**Report: Deficiency Report
Function: Test, Adjust, & Balance
Date: 12/17/2025
Completed By: National TAB**

PROJECT
City BBQ (Johnson City, TN)

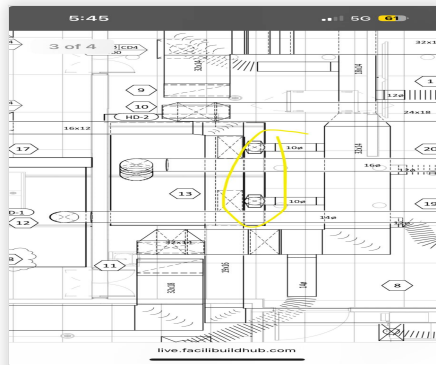
Issue Name : No OA on RTU's
Description : None of the RTU's have OA intakes. OA could not be balanced.
Created By : National TAB **Assigned To :** National TAB - Dan Hertenstein
Status : Open
Priority : Urgent **Asset Tag :**
Originated Date : 12/17/2025 - Christian Moller - National TAB
